**ADDENDUM  
NO. 02**

**March 14, 2022**

**Warren Central High School Phase 3 Renovation and Addition  
9500 E. 16<sup>th</sup> Street  
Indianapolis, IN 46229**

This Addendum consists of Pages ADD 2-1 through ADD 2- 5, and attached CSO Architects Addendum No. 2 , dated March 13, 2023, consisting of 11 Pages, Specification Section 02 01 00 – Maintenance of Existing Conditions, and Addendum 2 Drawings: C101, C102, C401, C501, C502, C503, LD001, L101, L106, L201, L206, L301, L306, S201PRT, S202PRT, S501, S601, AD201N, A201M, A201N, A202N, A211G, A211M, A211N, A401, A404, A423, A431, A432, A600, A601, A602, A603, A611, A612, A701, A702, A703, A800, A801F, A801J, A801M, A801N, A801P, A801R, A801T, A802F, A802N, A802P, A802R, A802T, A900A, A900B, A901K, A902U, A903, A904, A905, A906, MD201F, MD201H, MD201J, MD201K, MD201L, MD202HJ, MD202N, M201F, M201J, M201K, M201L, M201N, M202HJ, M202N, M211F, M211H, M211J, M211K, M211L, M211N, M212HJ, M301, M303.

3.14 SHEET S201PRT – FOUNDATION PLAN – UNITS P, R& T

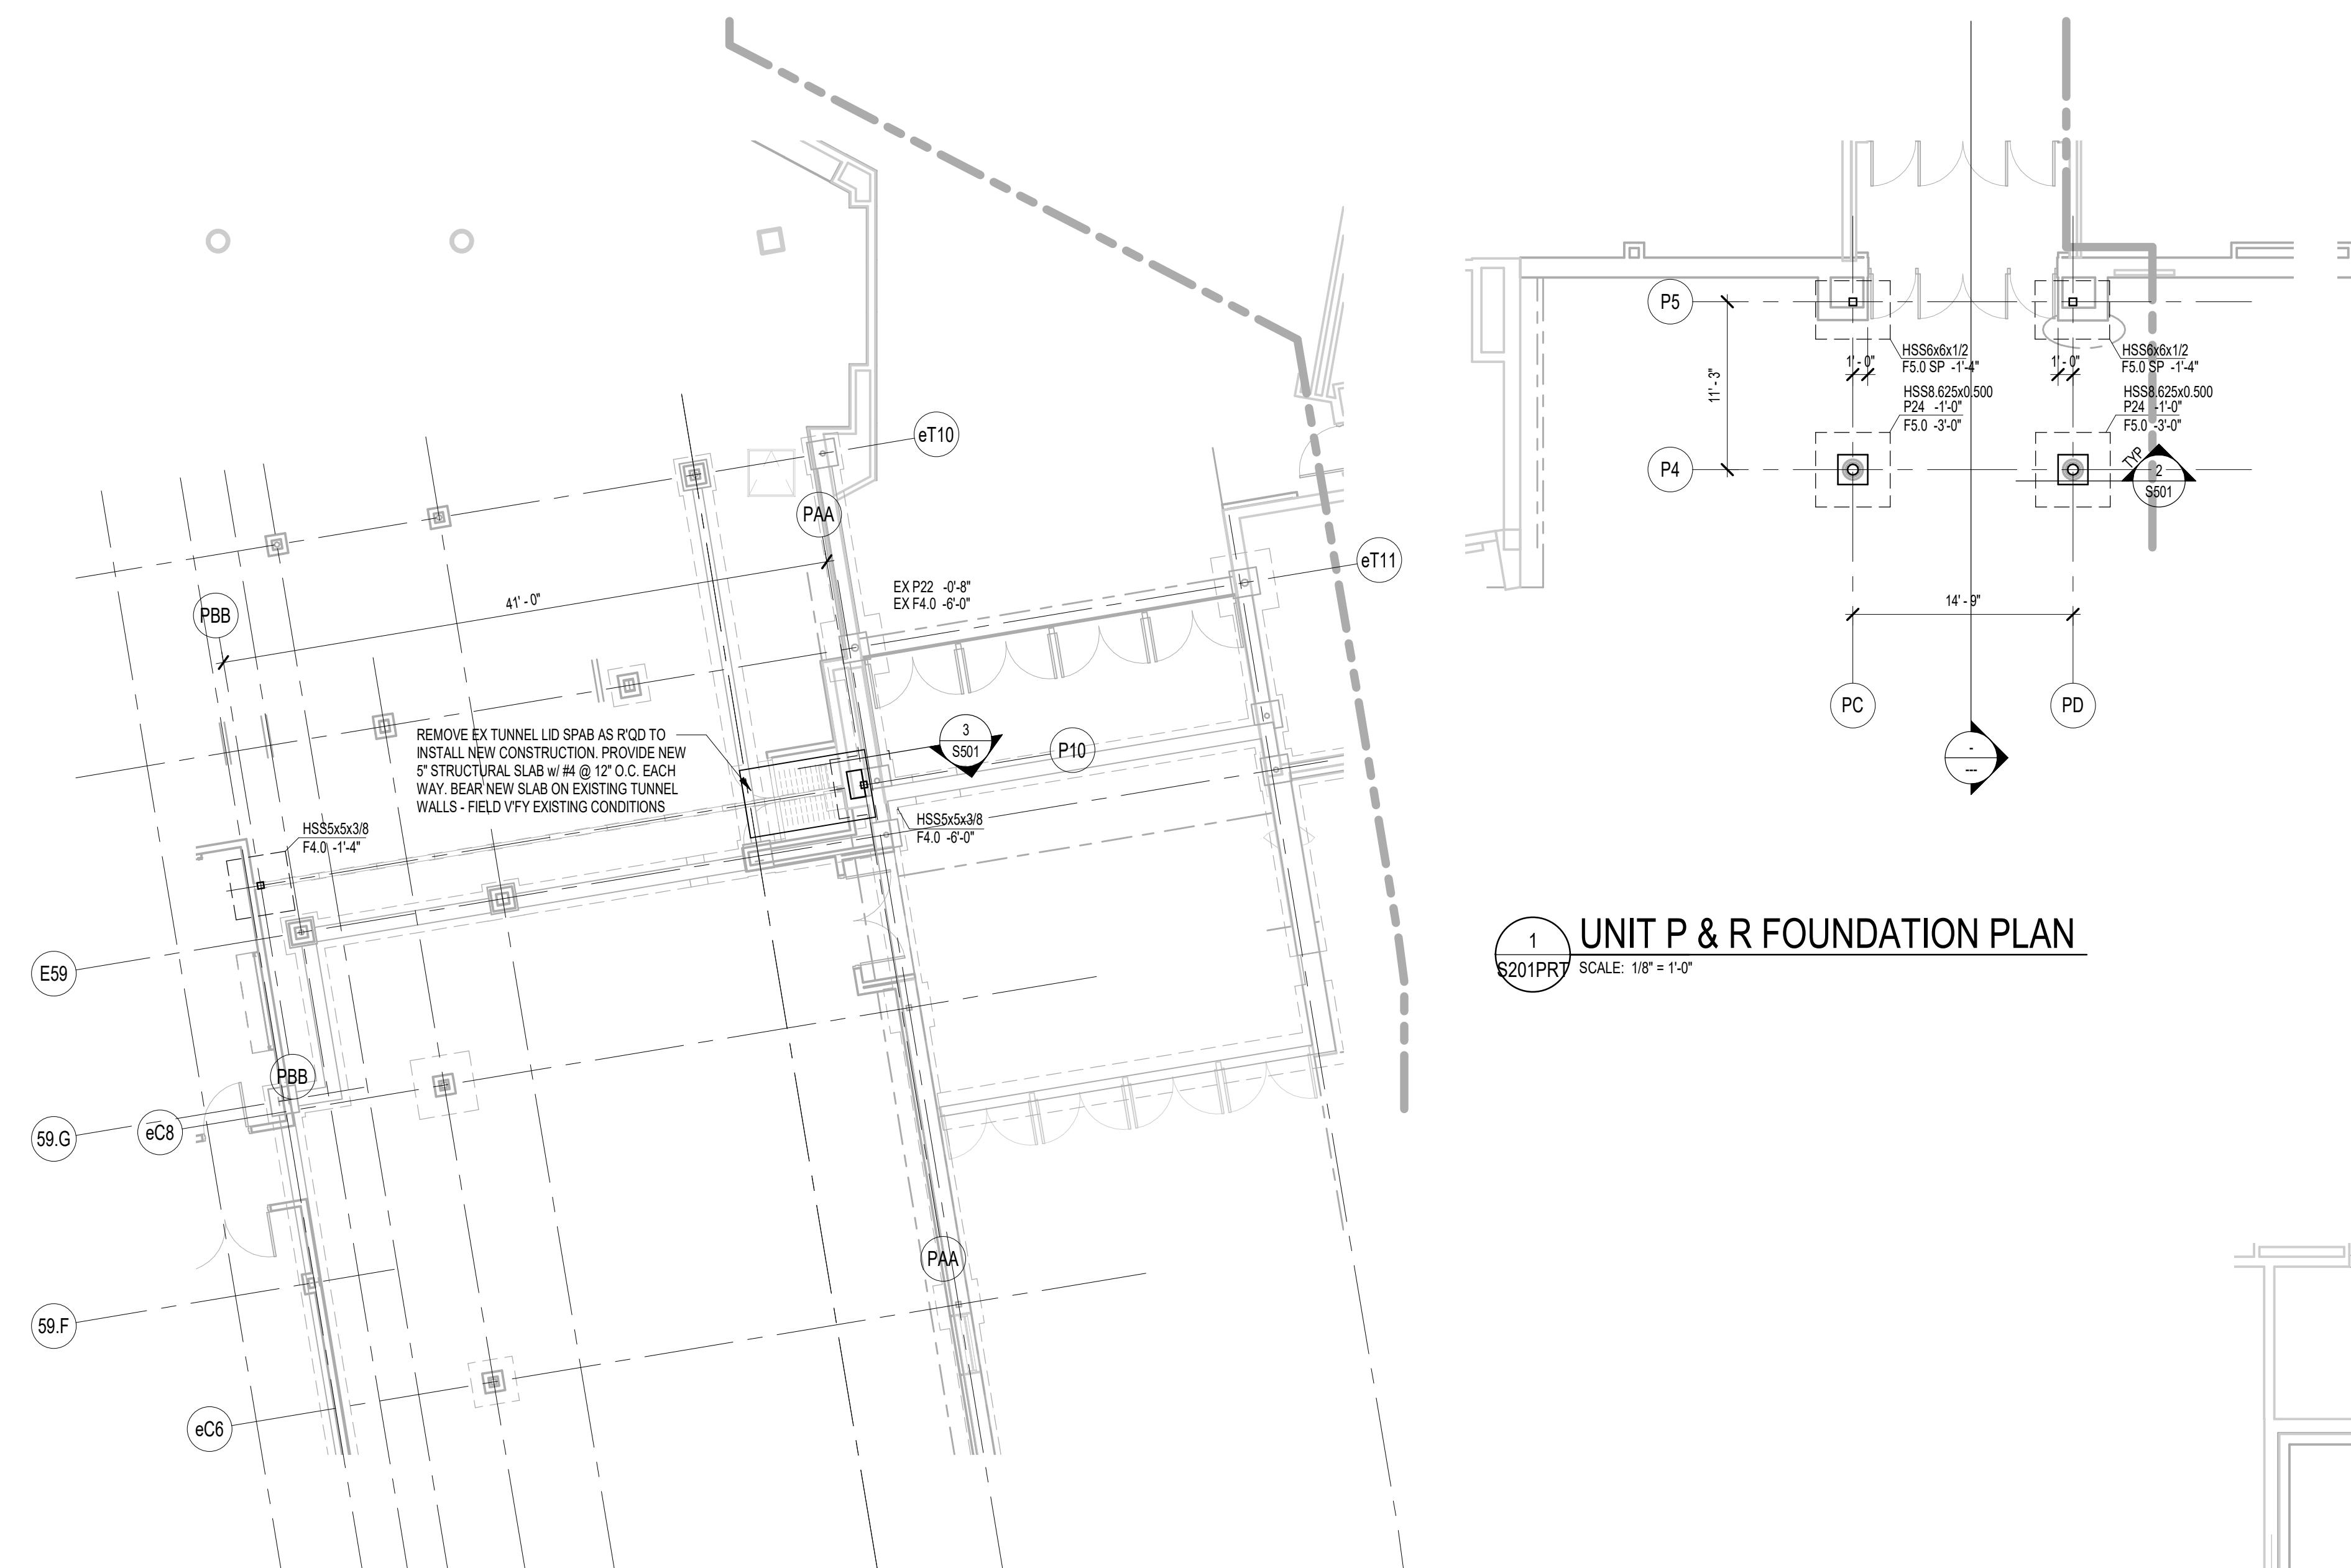
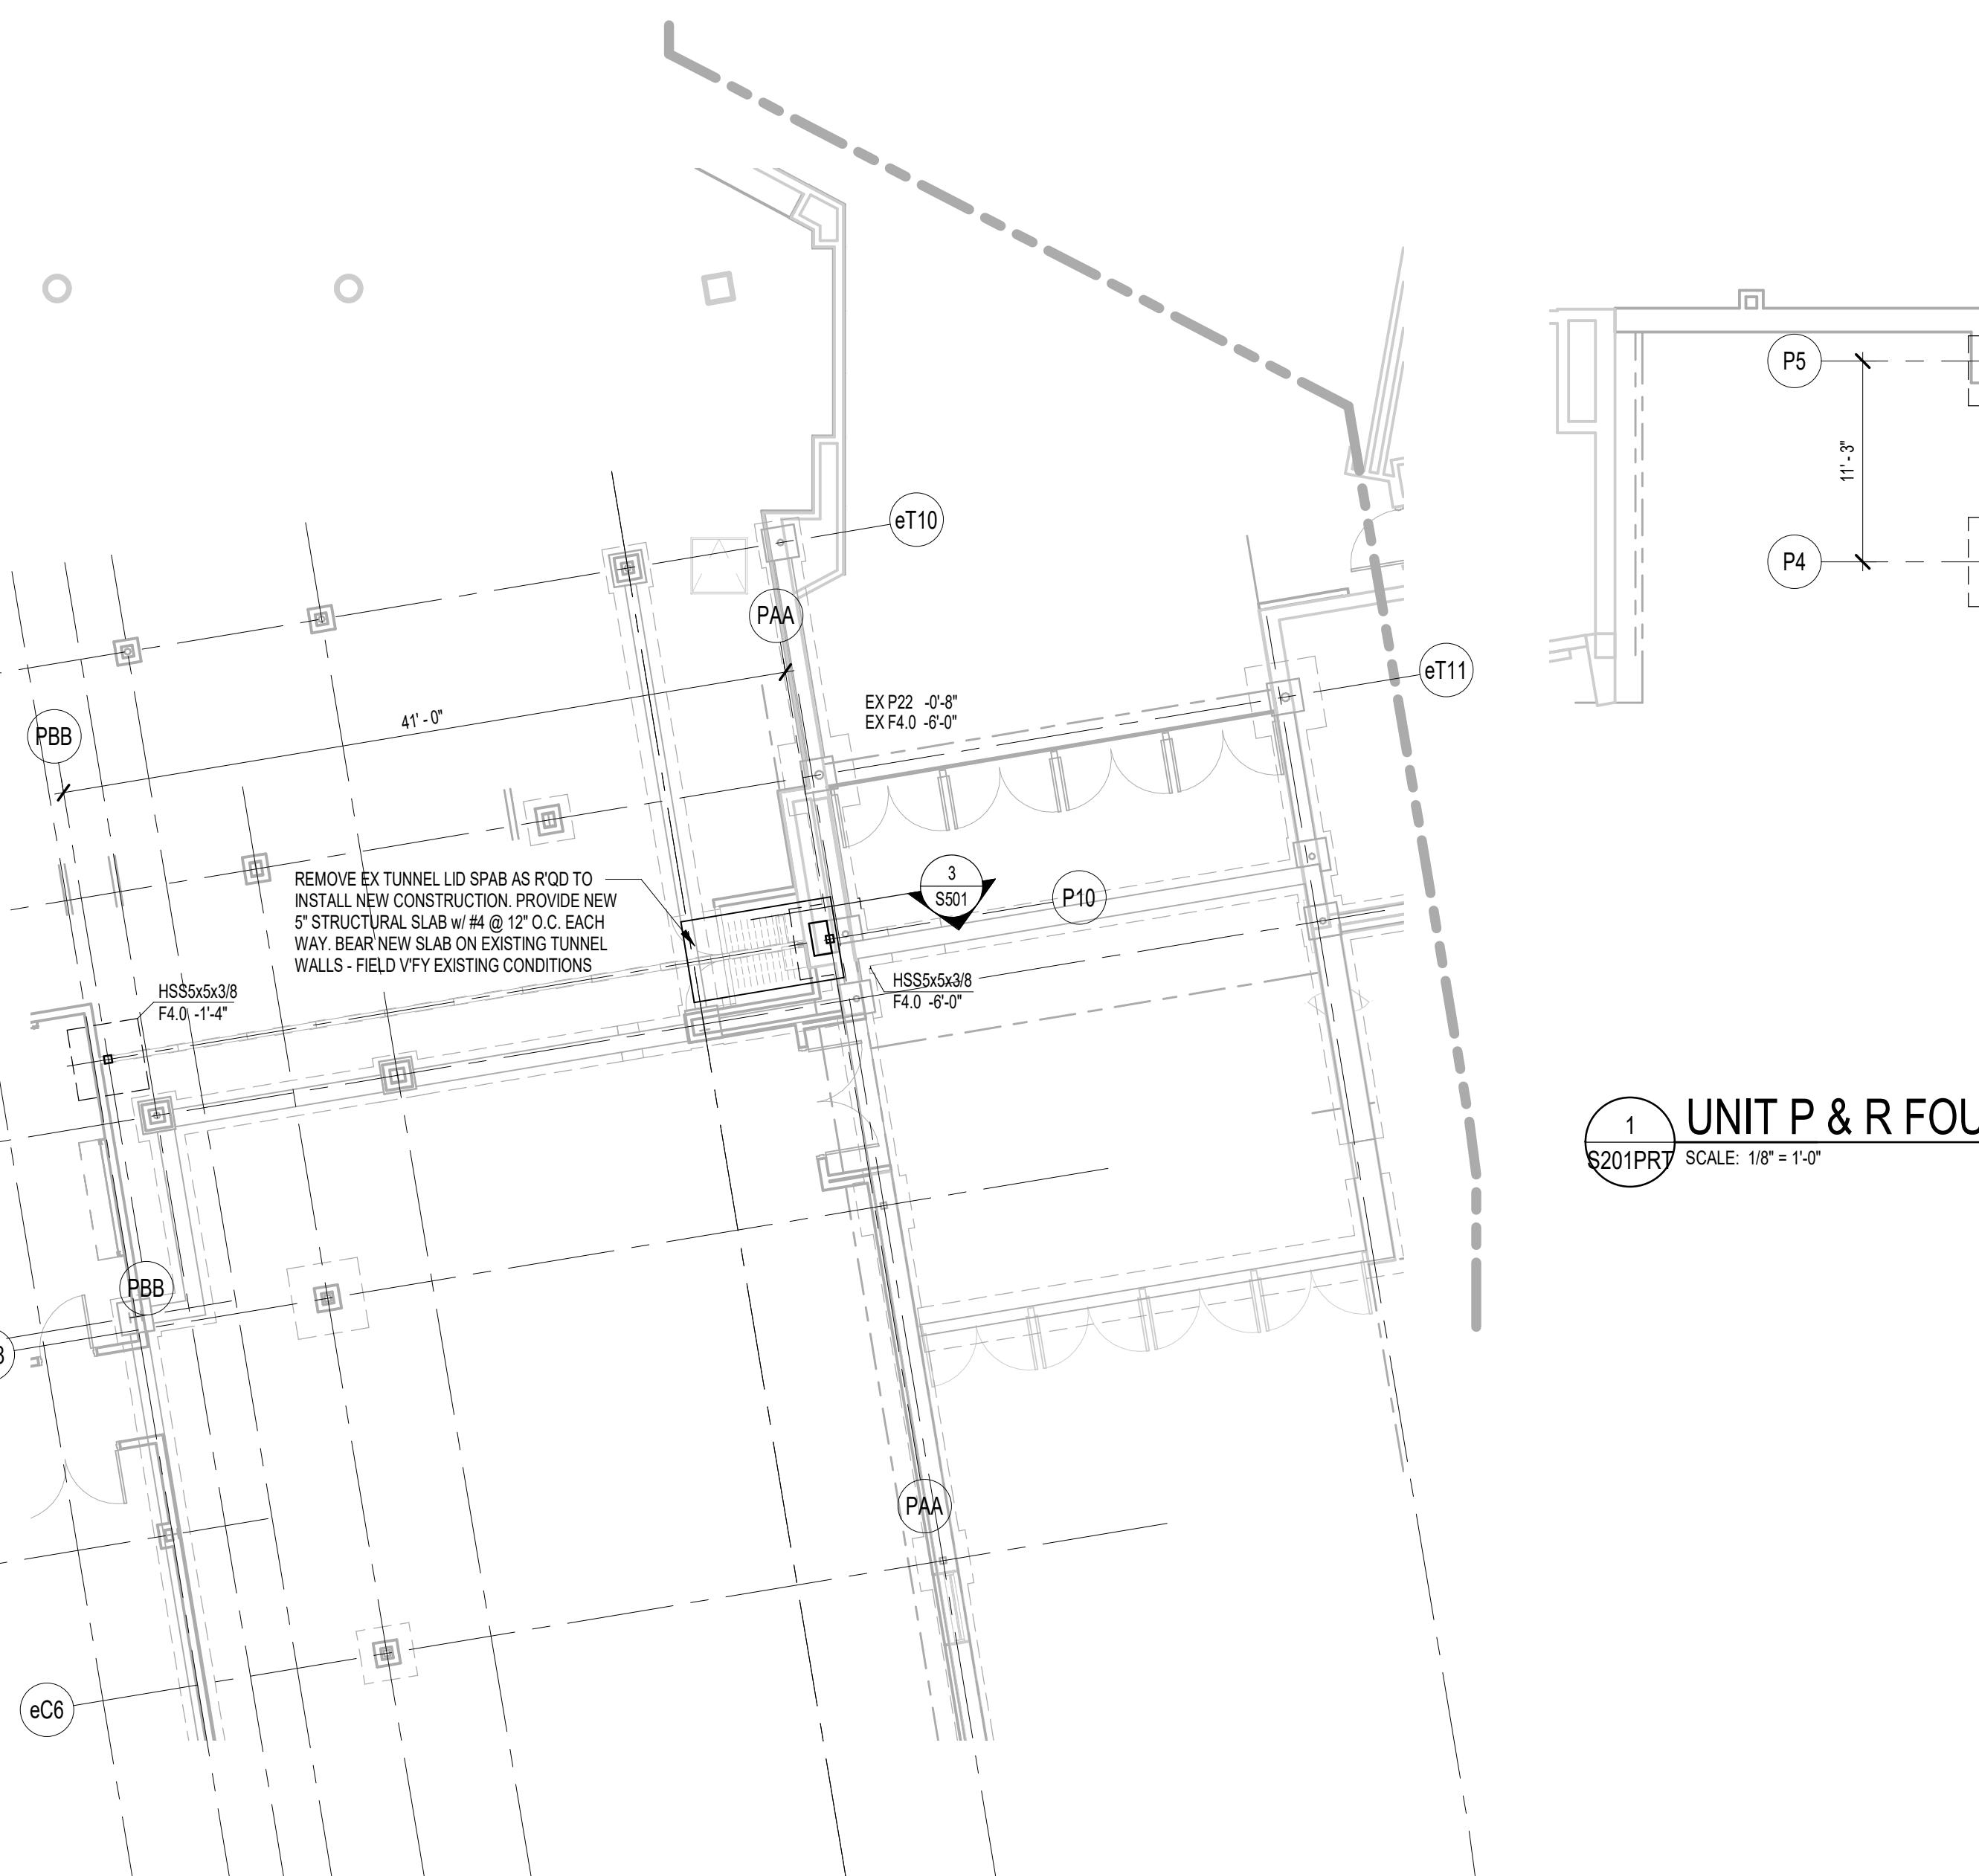
A. MODIFY column grid PA & PB dimensions as indicated on attached, re-issued Sheet S201PRT.

3.16 SHEET S501 – FOUNDATION SECTIONS

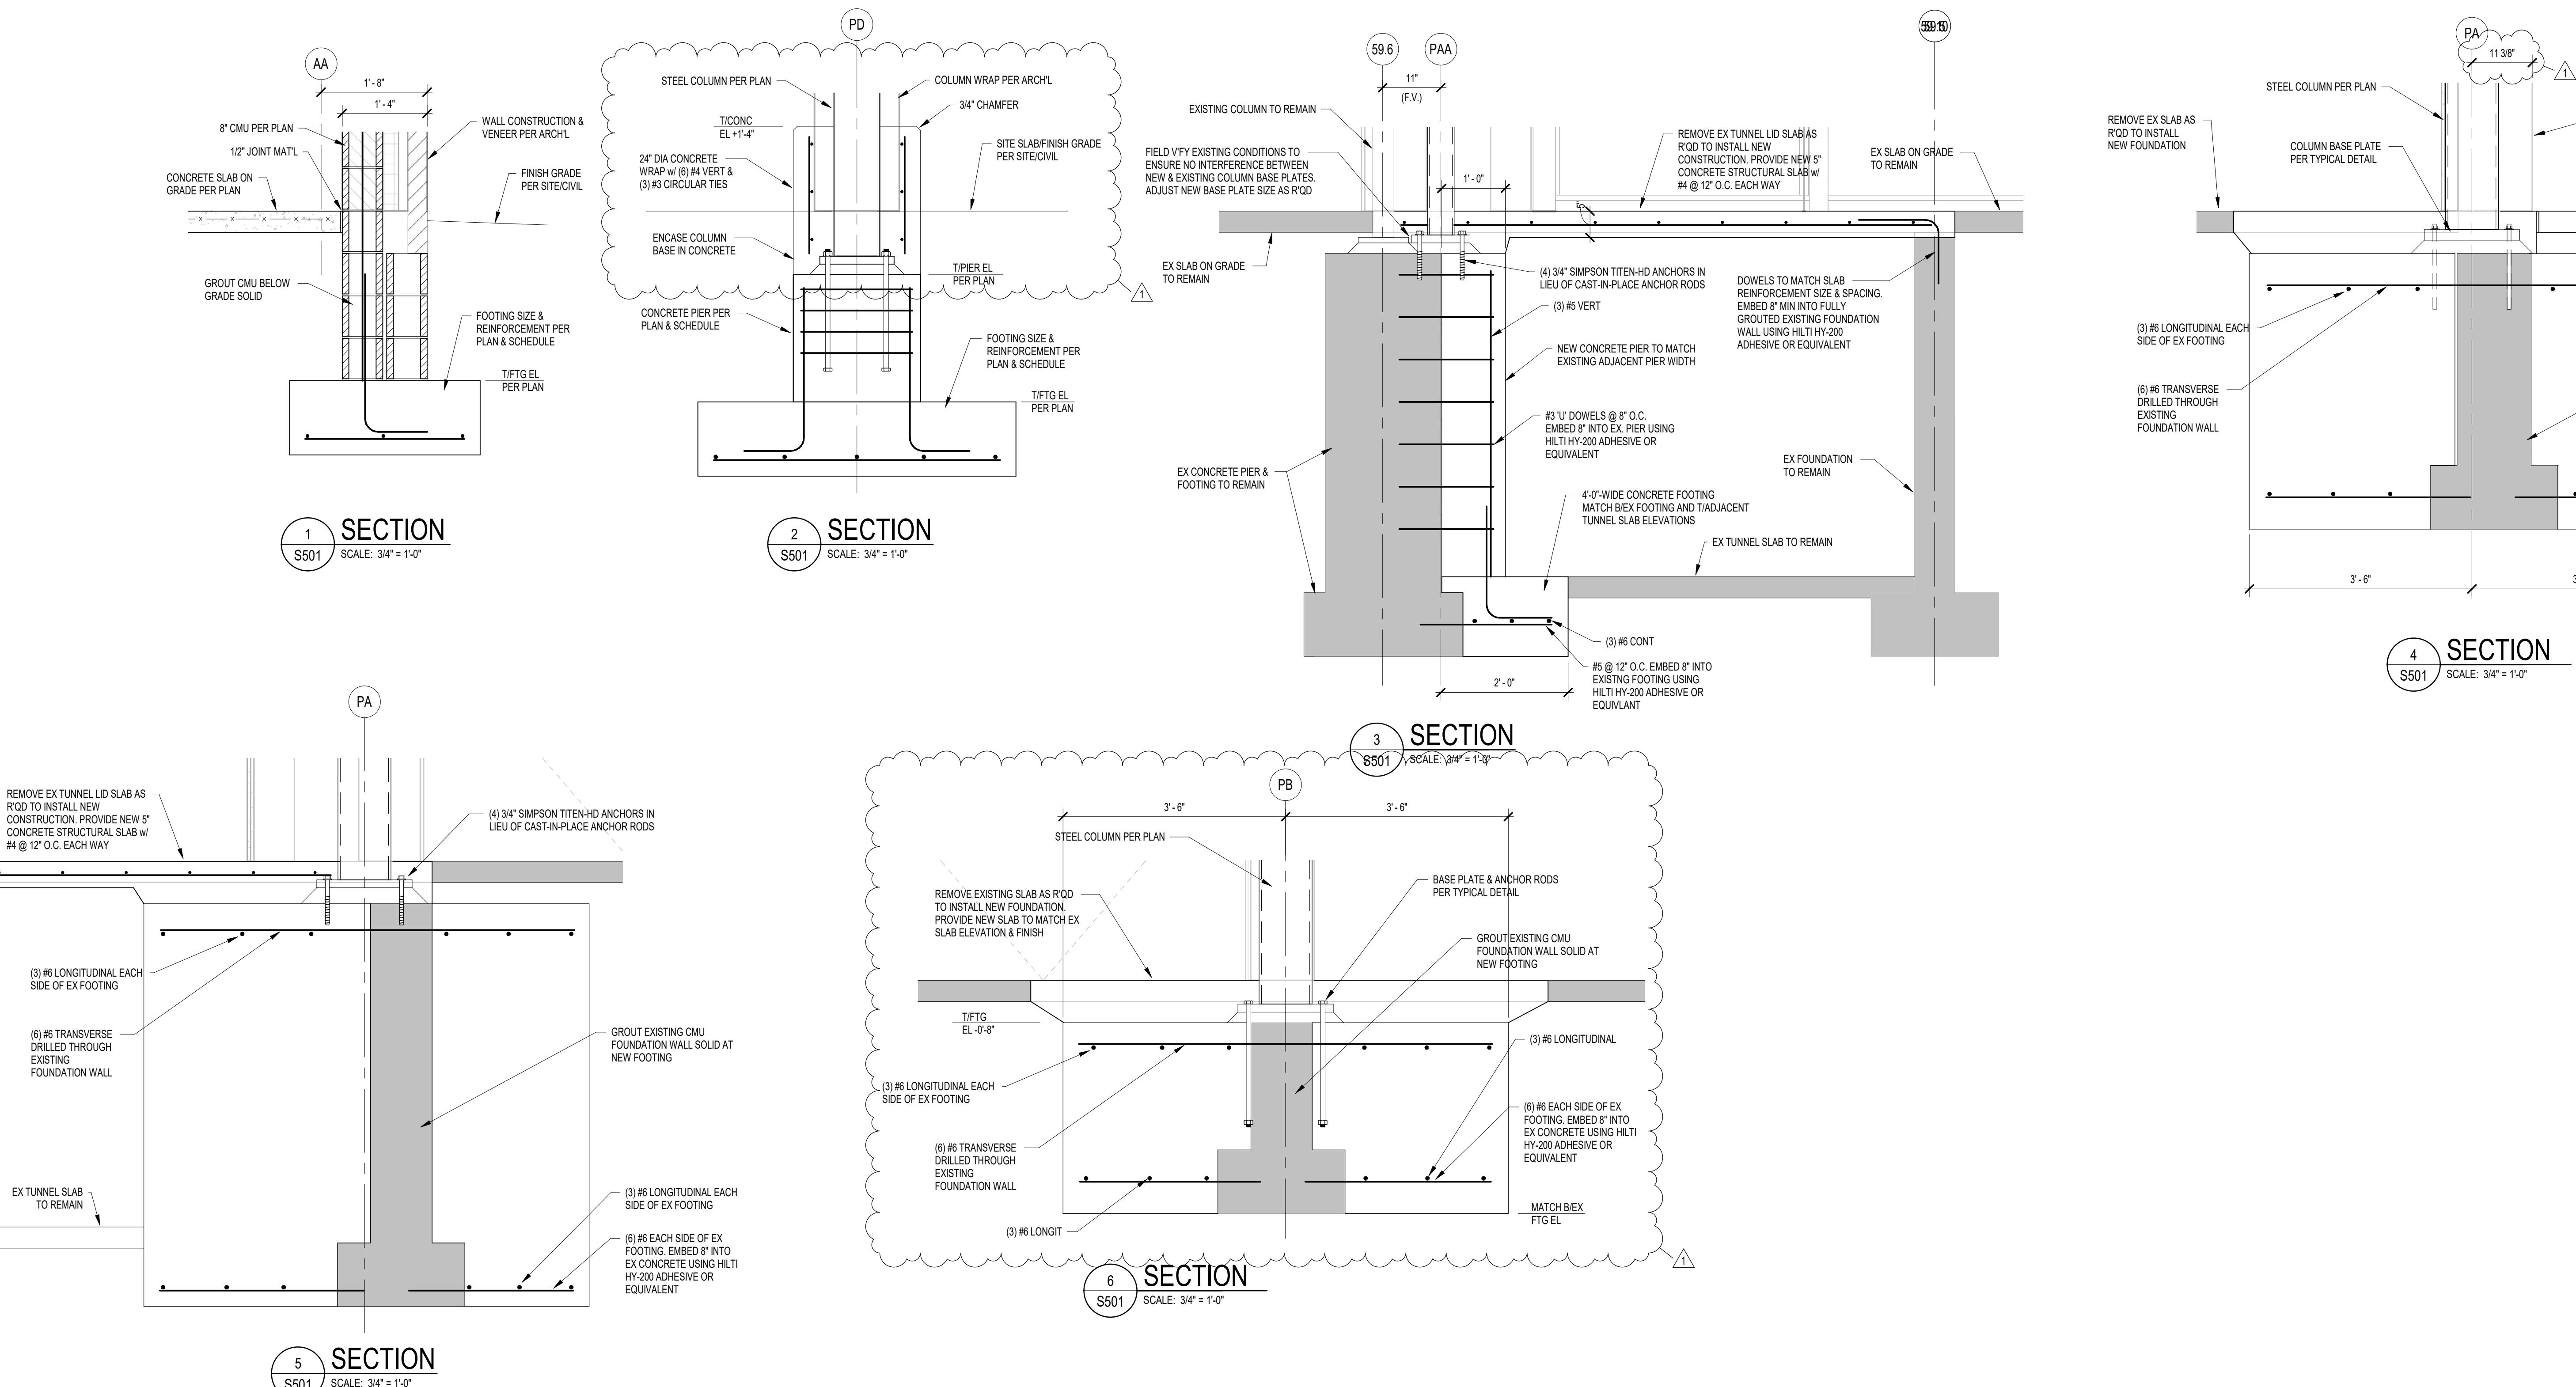
A. MODIFY sections 2 and 6 on attached, re-issued Sheet S501.
